Sisal Composite Limited (Relocated)

Purbohati, Natunpara, Hemayetpur, Savar, Dhaka, Bangladesh.

8 November 2023

2. Observations:

Observation-1: Mismatch in as-built drawing. (Main Building)

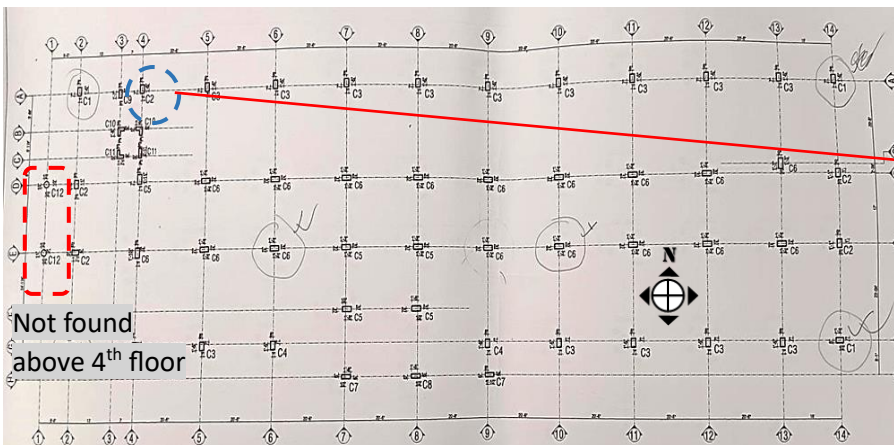
Floor buildup, false ceiling and partition wall height missing in architectural drawing

Column orientation mismatch

Description: Toilet floor buildup, false ceiling and partition wall height not mentioned in the architectural drawing. Column orientation mismatch found at GL-4A. Also, marked C12 column not found above 4th floor. Building engineer is required to update the as built drawings.

Material strength consideration from design report

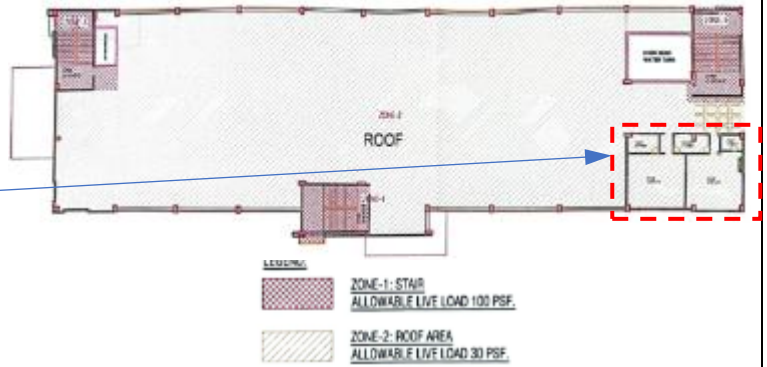
Description: As per the design report, concrete strength of beam and slab was considered 3500 psi (24.13 MPa). Only 6 sets of cylinder test reports were available on-site for floor beam & slab which doesn't meet the BNBC requirement. To confirm the design strength, the building engineer is required to verify the strength of concrete by taking adequate core samples from beam and slab.

Load plan of storeroom at roof (1.5kPa)

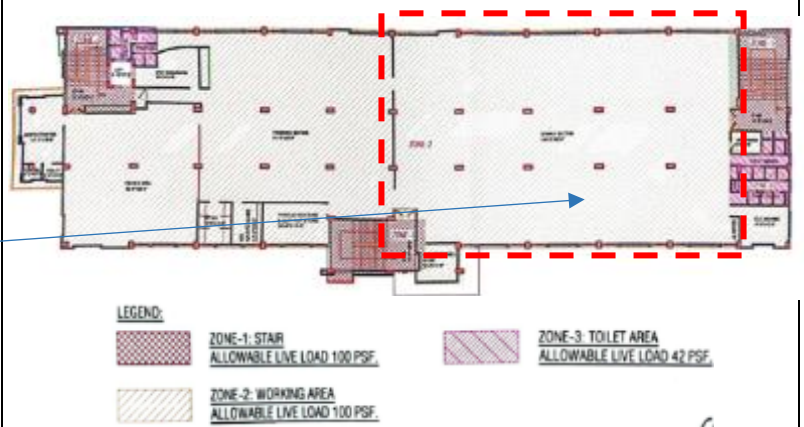
Description: According to BNBC 2006, a minimum of 6 kPa live load required to be considered for light storage. In the load plan and design report, 1.5 kPa & 4.8 kPa live load is considered for storage at roof and 3rd floor respectively. The building engineer is required to revise the load plan for storage area based on the BNBC live load requirement, update the design report accordingly.

Pile layout plan

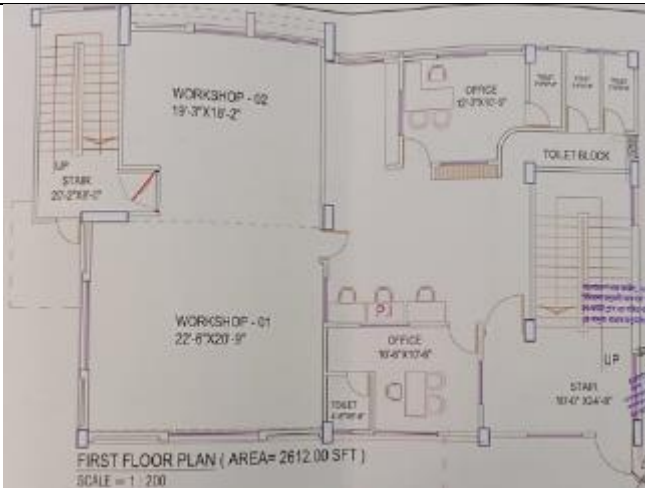
Description: Cursory calculation indicates that the marked pile foundations are marginally overstressed based on 5kPa typical floor live load, 6kPa storage live load and observed water load considering allowable pile capacity 58 ton (FoS-2.5) based on soil test report (Table-1). Building engineer is required to carry out Detailed Engineering Assessment (DEA) based on in-situ material strength, minimum floor live loads as per BNBC and submit to RSC for review.
